# Jersey Central Power & Light Company

SUBJECT: FUEL DENSIFICATION

### EXXON NUCLEAR OYSTER CREEK DENSIFICATION ANALYSIS

PROPOSED TECHNICAL SPECIFICATION CHANGE

FIGURE 1

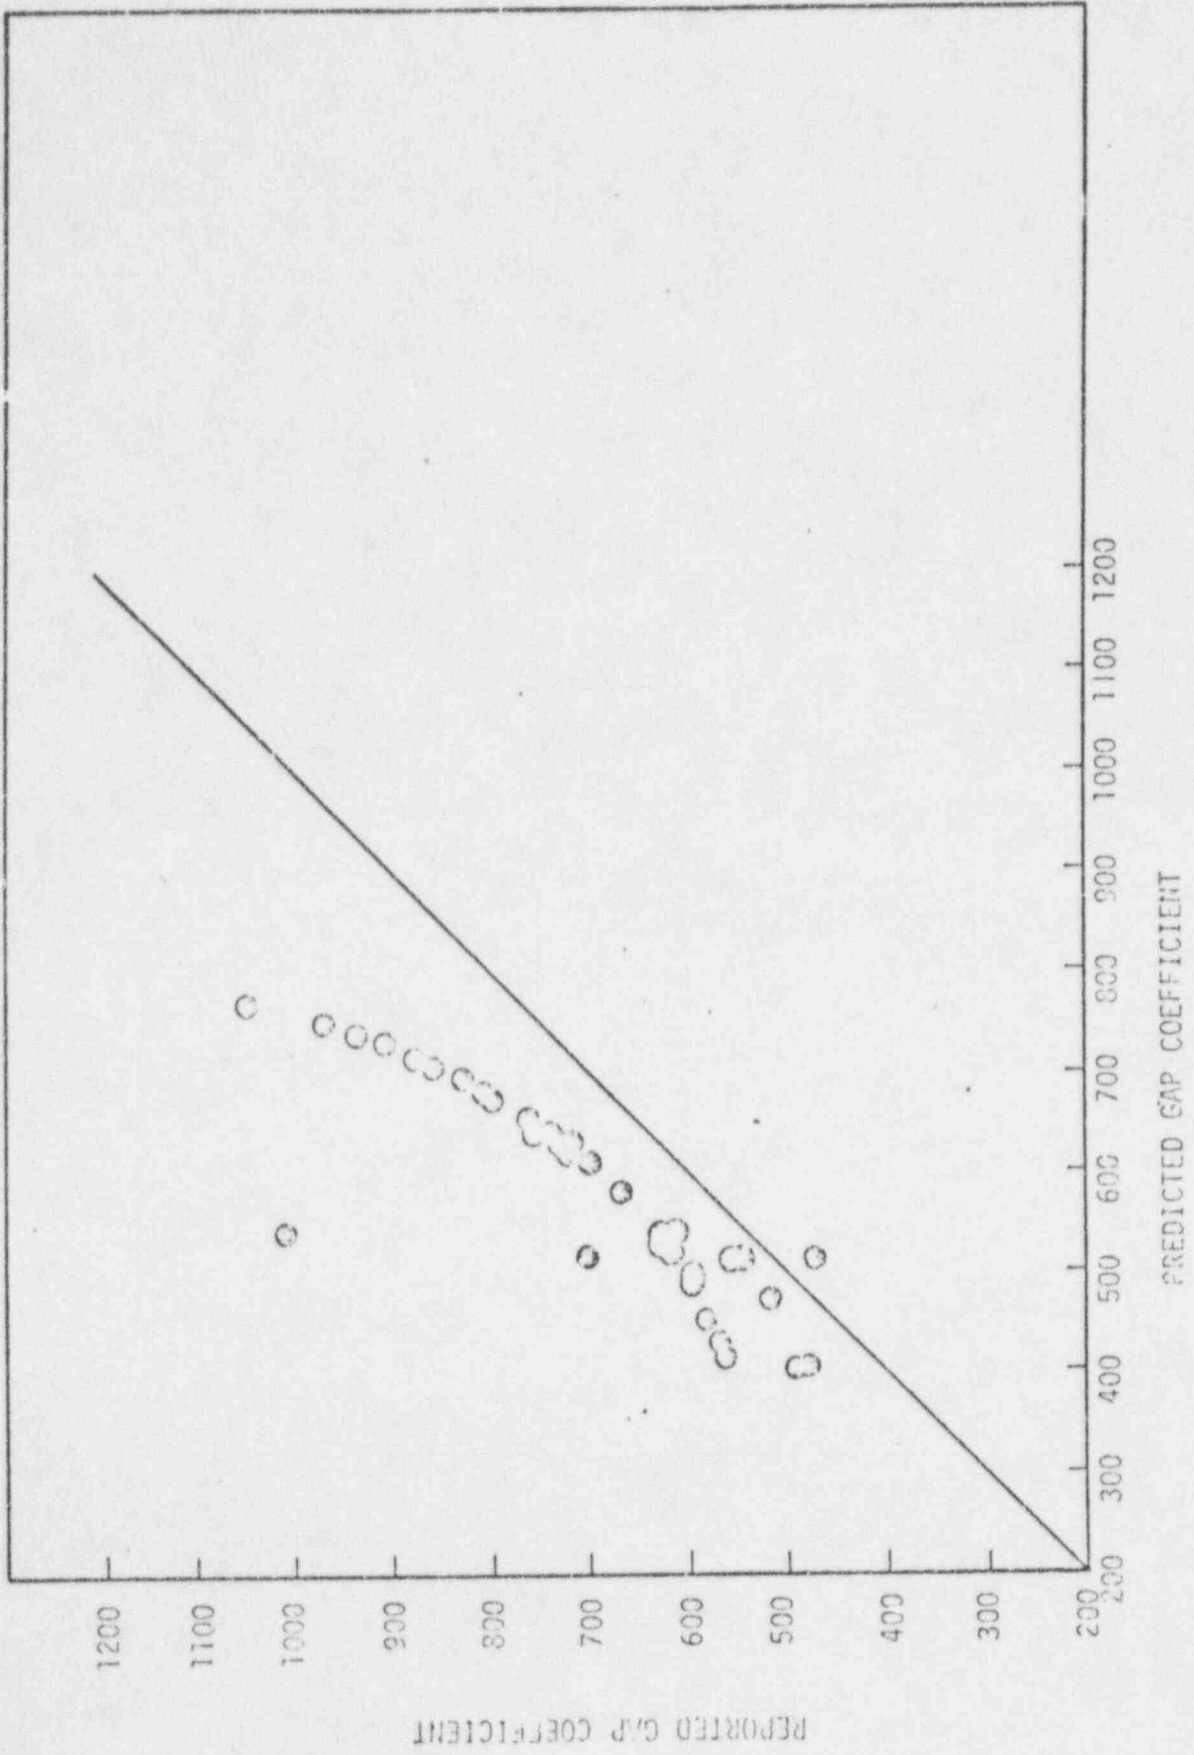
Figure 1 provides a comparison of the prediction with the 95/90 empirical gap coefficient model and the reported gap coefficients. All of the reported gap coefficients except a single point from Reference (4) at 7.5 kw/ft, a g/D = 0.0326 and reported gap coefficient of 473 Btu/hr.-ft<sup>2</sup>-°F are shown to be underpredicted in Figure 1.

FIGURE 2

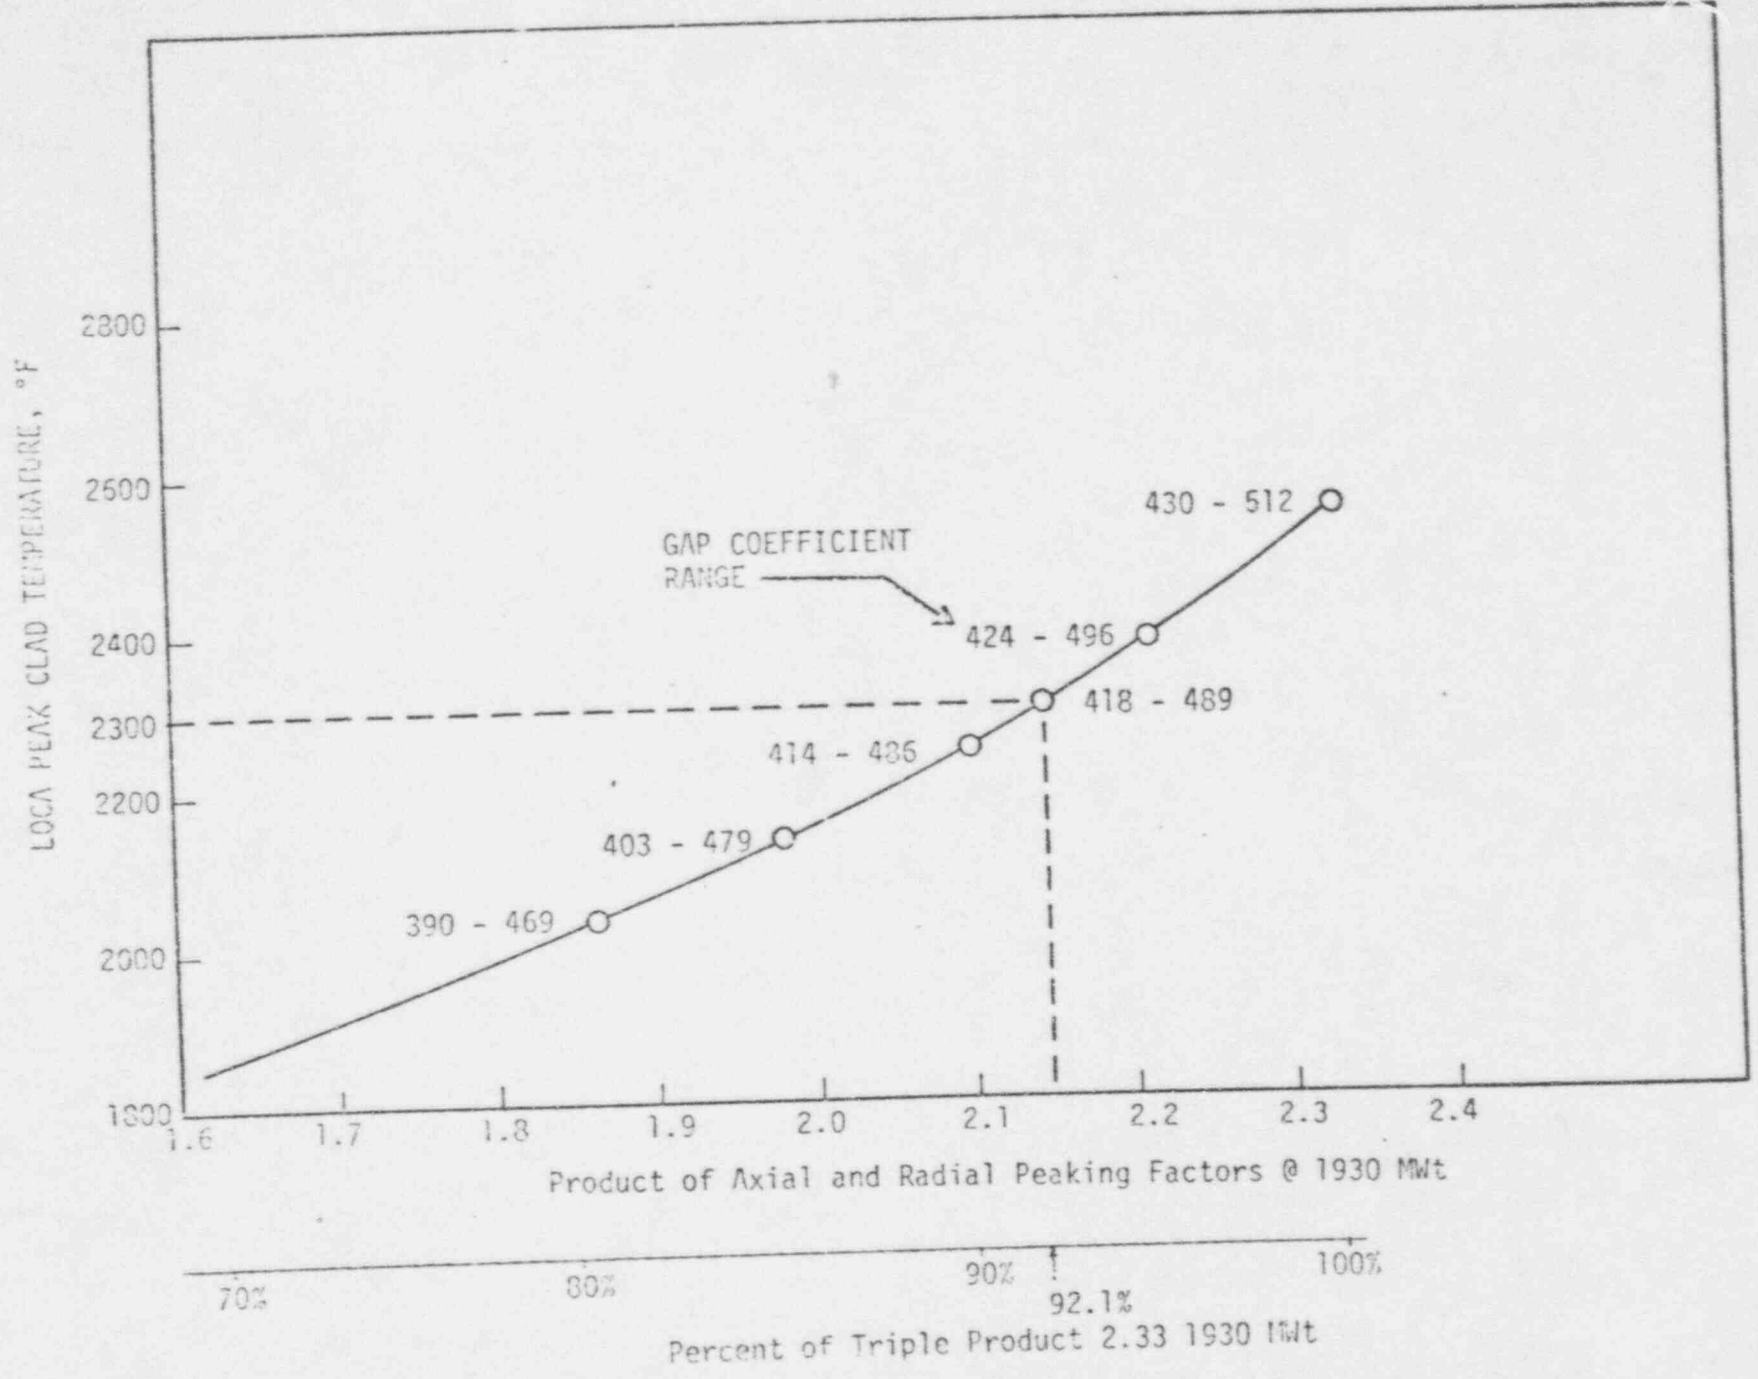
The cold fuel pellet OD is adjusted using this value and a "densified" pellet-to-clad cold gap obtained. The curves derived from fits to the experimental data described above were used in conjunction with the "densified" cold gaps to obtain gap conductivities for each fuel rod. These values are then used to calculate the peak clad temperature during the LOCA as described in FCR No. 3, January 13, 1973. The results of this calculation are presented in Figure 2, where the peak clad temperature is plotted as a function of the product of the axial x radial peaking factors, with the reactor power assumed to be 1930 MWth. This figure indicates that the peak clad temperature is 2300 °F when the axial x radial product is 2.146. The range of gap coefficients for several values of this product is as shown on the figure.
